Greater Western Battery Energy Storage System – EIS Exhibition

BCS has reviewed the Biodiversity Development Assessment Report (BDAR) for the project. Our biodiversity recommendations are provided in **Attachment A** and detailed comments are provided in **Attachment B**.

Greater Western Battery Energy Storage System – Environmental Impact Statement

Figure 1 Mapped native vegetation extent within 1500m buffer

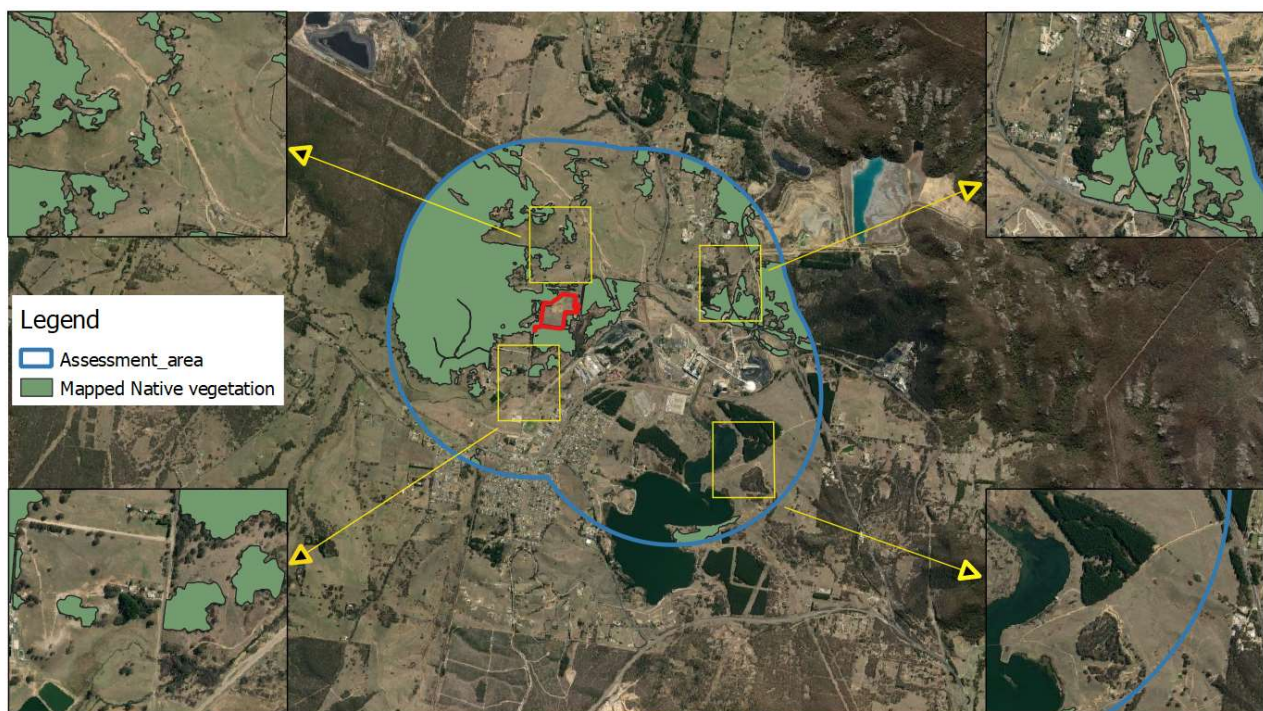
BCS notes that the native vegetation cover within the 1500m landscape buffer has only been coarsely mapped. An example of potential native vegetation which has not been included within the vegetation cover class assessment has been provided in Figure 1 below.

In addition, areas of native vegetation extent (derived native grassland) have been excluded from Figure 4 of the BDAR and the landscape vegetation assessment despite these areas being identified within the subject site's native vegetation extent mapping in Figure 5.

The assessor should note that, native vegetation extent identified and mapped within the subject site (inclusive of both woody and non-woody native vegetation) is required to be included within the native vegetation cover polygon on the landscape assessment map and the vegetation % cover class assessment (Section 3.2 of the BAM 2020).

Further clarification is provided in the Native Vegetation Cover Section of the BAM Operational Manual Stage 1 which states that the mapping requirements for the landscape vegetation cover class assessment must mirror that for the subject site and must be inclusive of all areas of native vegetation, including areas which are ground cover only.

The assessor should undertake finer scale vegetation extent mapping and include both woody and non-woody vegetation, in accordance with the requirements set out within Section 3.2 of the BAM 2020.

3.1. Undertake finer scale vegetation extent mapping and include both woody and non-woody vegetation within mapping

Figure 3 *Veronica blakelyi* population identified adjacent to the construction footprint

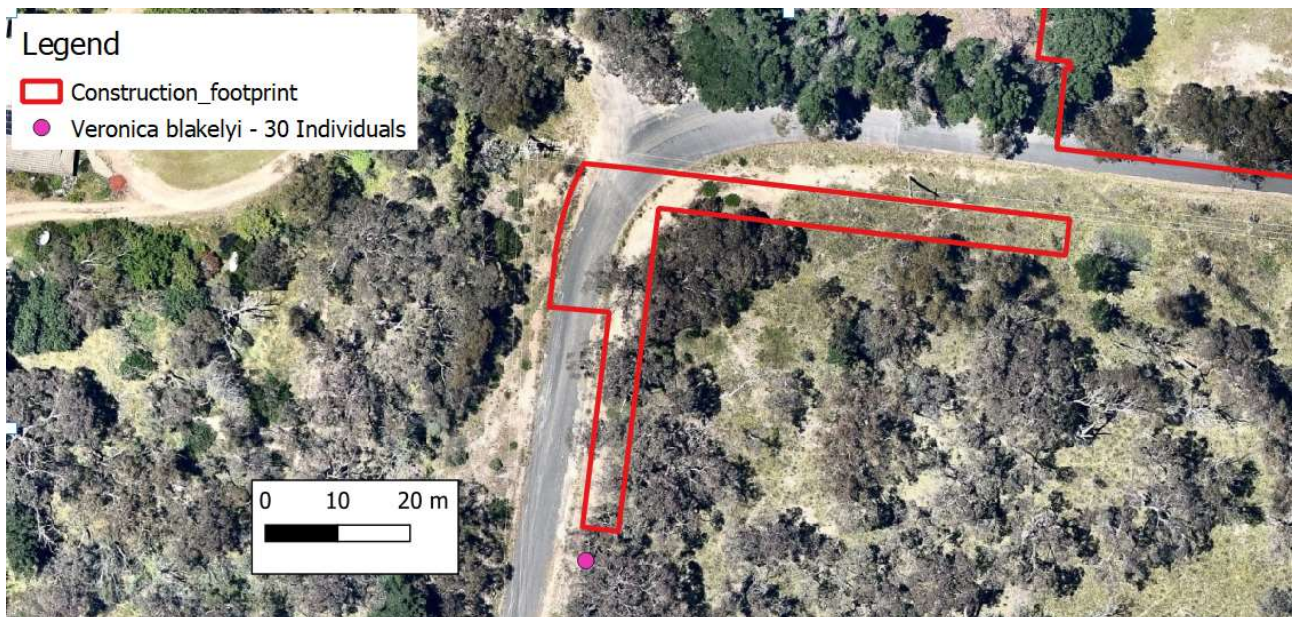
From the spatial data provided to BCS it is noted that a population of 30 individuals of *Veronica blakelyi* were identified directly adjacent to the outer boundary of the project's construction footprint (See Figure 3 below).

Section 8 of the BAM 2020 states that the assessor must assess the direct, indirect and prescribed impacts resulting from the project, this includes the following impacts which would likely be relevant to this population:

- Direct loss via clearing of habitat or individuals
- Indirect impacts, including:
 - inadvertent impacts on adjacent habitat or vegetation

- reduced viability of adjacent habitat due to edge effects
- reduced viability of adjacent habitat due to noise, dust or light spill
- transport of weeds and pathogens from the site to adjacent vegetation
- trampling of threatened flora species

The assessor should assess all impacts resulting from the development on the identified population of *Veronica blakelyi*. All residual impacts, including residual indirect impacts, should be calculated and offset.

- 9.1. Assess all impacts resulting from the development on the identified population of *Veronica blakelyi*. All residual impacts, including residual indirect impacts, should be calculated and offset.

Figure 4 Extract of inconsistent Figures within the BDAR (red squares delineating discrepancies)

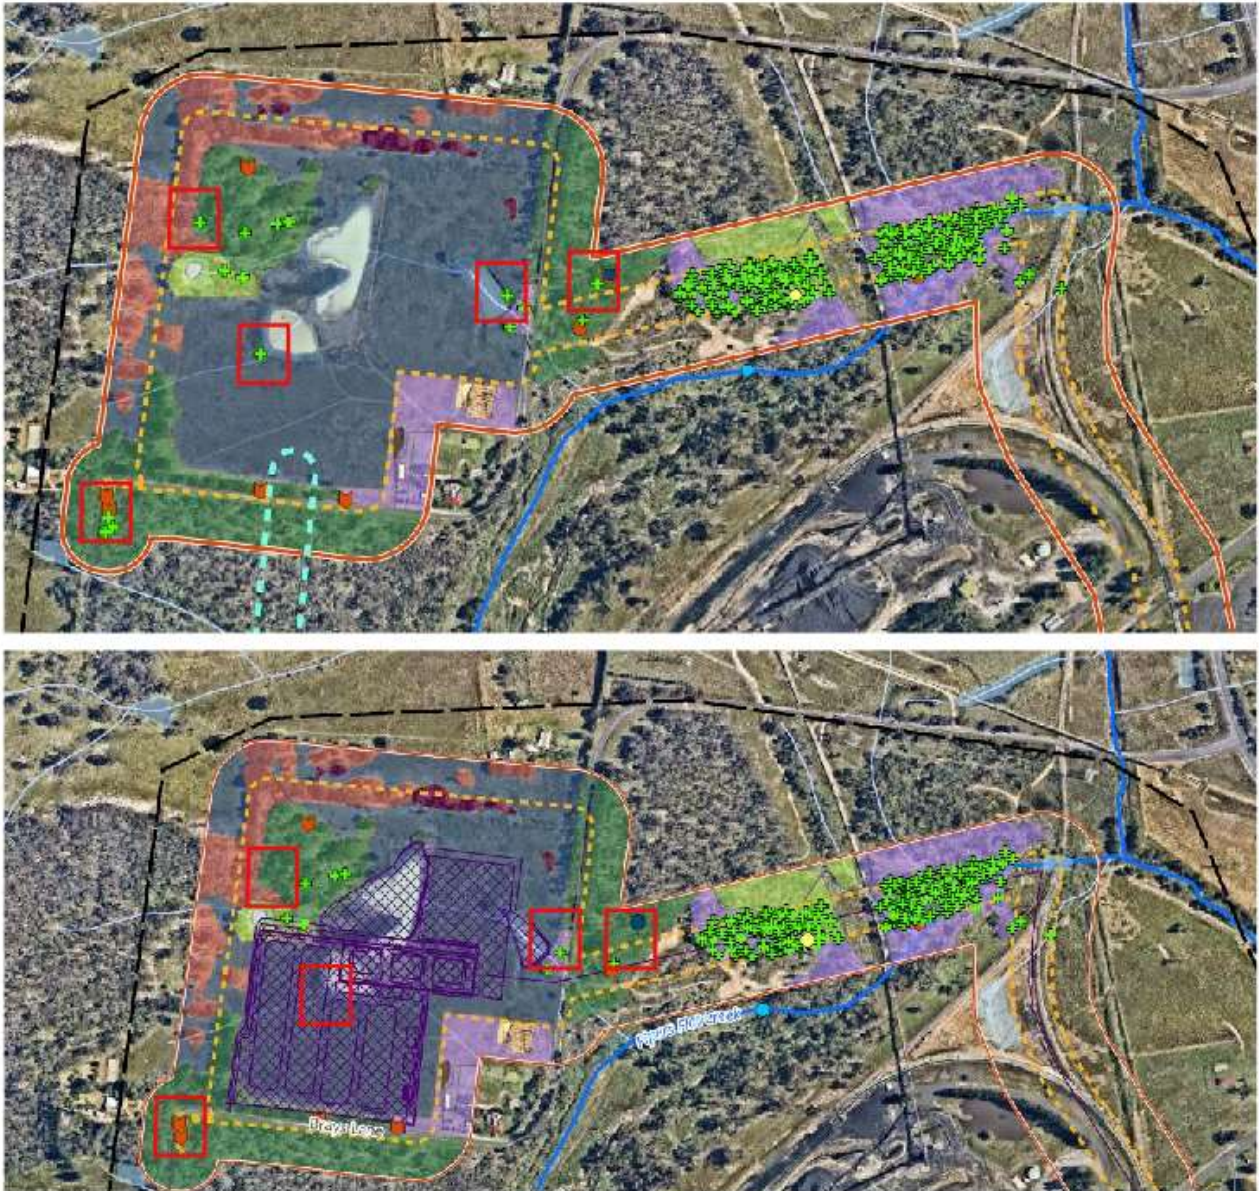
There are several figures within the BDAR which display the locations of all Black Gums located within the subject site. However, some figures show a significantly higher amount of Black Gums present which are absent from others.

As an example, Figure 11 displays individuals of Black Gum which are absent from Figure 10. The discrepancies between these two maps are shown in Figure 4 below.

From BCS review of the BAM-C only two individuals of Black Gum are proposed to be cleared for the project. However, there is additional Black Gums identified within the centre of the proposed construction footprint in some figures.

The inconsistencies between the figures in the BDAR should be updated, if any additional Black Gums are required for clearing the projects residual offset calculations this should also be updated.

- 10.1. Address the inconsistencies between figures within the BDAR and update the BAM-C calculations as necessary
